**From:** [REDACTED]  
**Sent:** 06 November 2020 12:36  
**To:** [REDACTED]  
**Subject:** RE: [External] 2020-10-28 MEH-MH Abandonment Order plan  
**Attachments:** Drg 6 REV A.PDF

**From:** [REDACTED]@hoy-dorman.com]  
**Sent:** 03 November 2020 16:59  
**To:** [REDACTED]@infrastructure-ni.gov.uk>  
**Cc:** [REDACTED]@infrastructure-ni.gov.uk>  
**Subject:** RE: [External] 2020-10-28 MEH-MH Abandonment Order plan

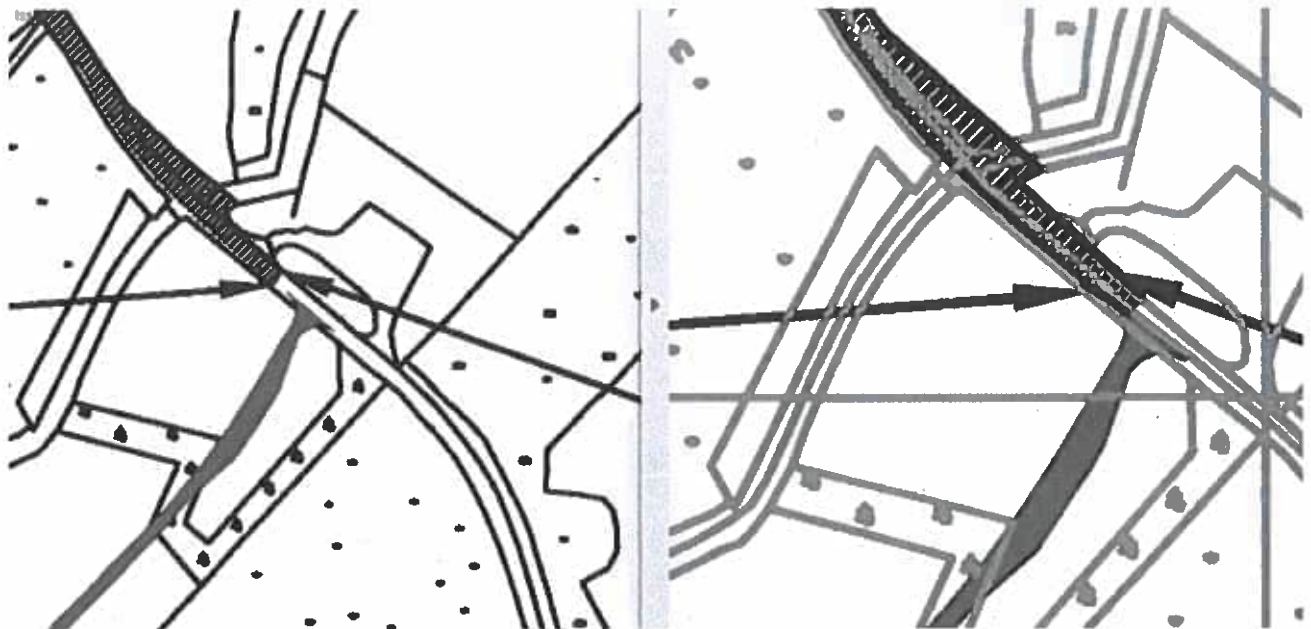
Is this plan (Drg 6 REV A) from the [Planning Portal](#) is the most up to date in terms of the Dalradian fenceline? Could you forward the fenceline on autocad so that [REDACTED] can use it to ensure we are using the same start and finish points for the abandonment extents?

- 1 Can you check the scale when printed, I'm not getting 1:5,000 when printing at A3 as stated on the drawing.
- 2 Happy to stick with the original length and area.
- 3 In the title block you are using it asks for Land area and Road Bed Area then Total Area, do you need to complete both then have the total of 0.617ha?
- 4 I notice a slight difference in your DfI Roads drawing relating to the location of the east stop up point. On the left below is the HD location, on the right is Roads location, just wondering is there a reason for this? Our location on the left is at the scheme fence line. Same at the west side there is a slight difference at the stopped up location when comparing Roads 2016 to draft 2020.

Actual measurement I'm getting 1,113m length and 5,528m2 area.

I see from the original Abandonment the length was 1,118m and 6,170m2 area. Roads done their own area and length in your cad work for the previous submission so I was proposing to keep with same as previous 2016 submission as where the centre of the road is and the actual boundary from verge to verge is subjective.

Please see attached which has been reviewed and length & area now align with the 2016 figures.

I have looked at the road boundary again on this plan and made some amendments. Find attached Rev 1 plan for your review.
